PERMIT

SEWAGE DISPOSAL SYSTEM

SUBDIVISION Triadelphia Woods ROAD 12301 Ericole Court LOT 23

LOCATION DRAWING
12301 ERICOLE COURT
TRIADELPHIA WOODS
3RD ELECTION DISTRICT
HOWARD COUNTY, MARYLAND

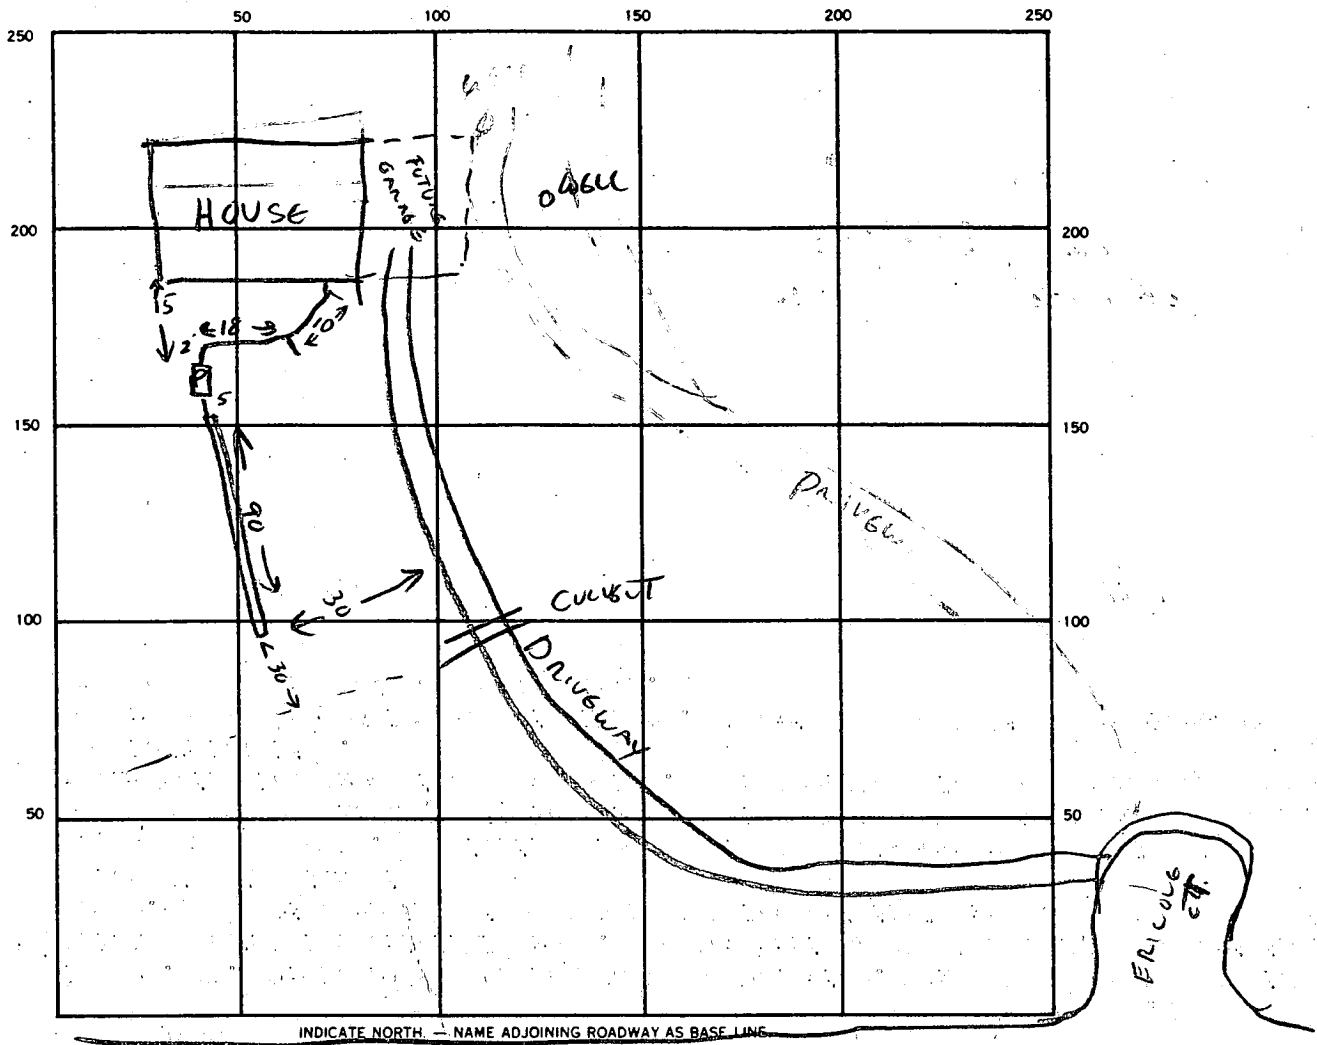
OK TO CHANGE TO 2' W/06
INLET 3' BOTTOM 9'
3/16/88 CW

REMARKS OK TO CONCR 3/16/88 CW

FIELD SHEET

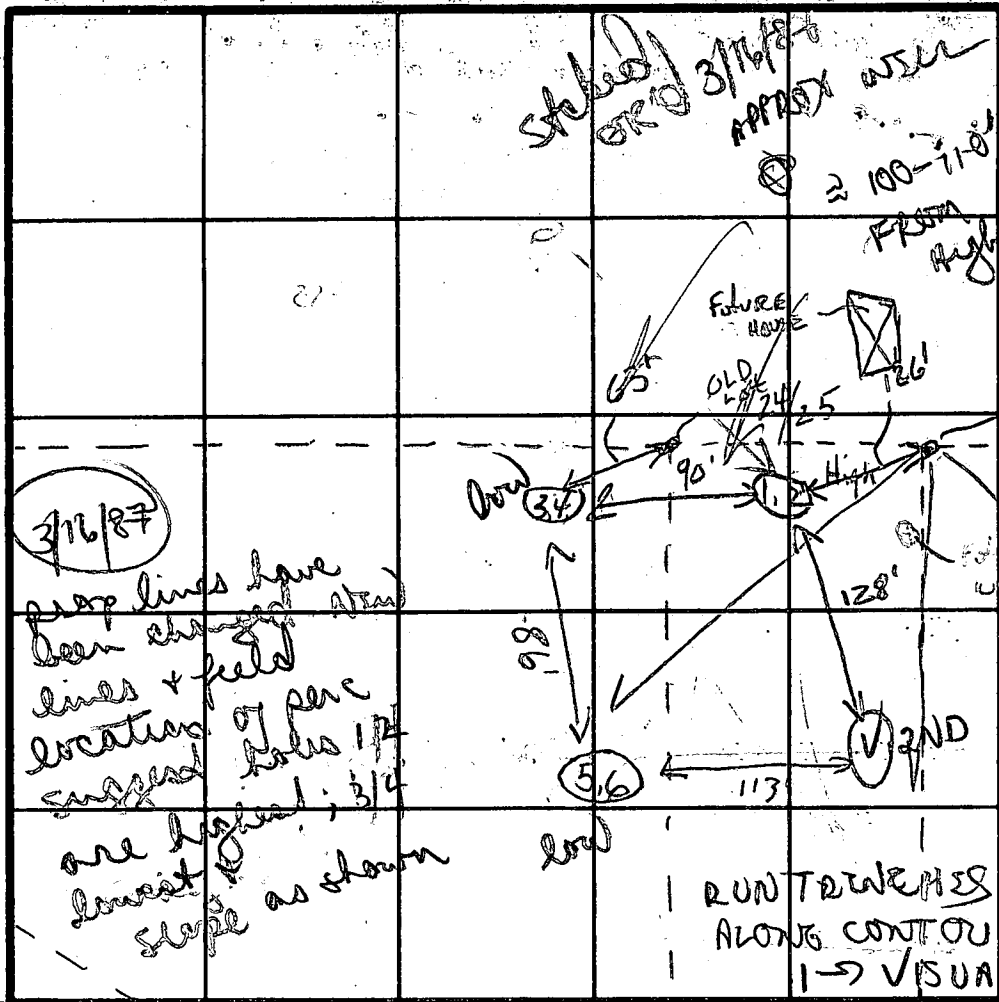
REASONS FOR REJECTION OR HOLDING 6-3-80 H/O for CERTIFIED HOLES + Lot Line Revision CBS+SR

6-3-80 WOODED Lot NOT STAKED
REMARKS Hold for CERTIFIED HOLES & CHANGE OF PROPERTY LINES PER D.MINK
